AMENDMENTS TO THE DRAWINGS

REMARKS

FIG. 1 (PRIOR ART)

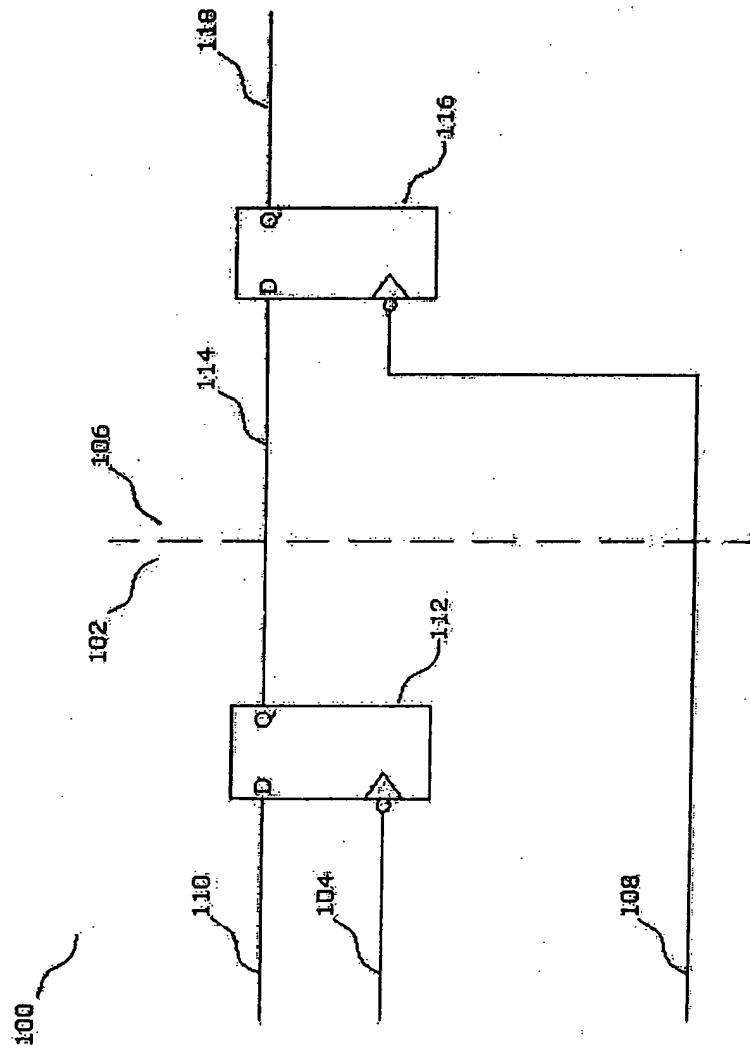
In FIG.1 the previously omitted legend "Prior Art" has been added.
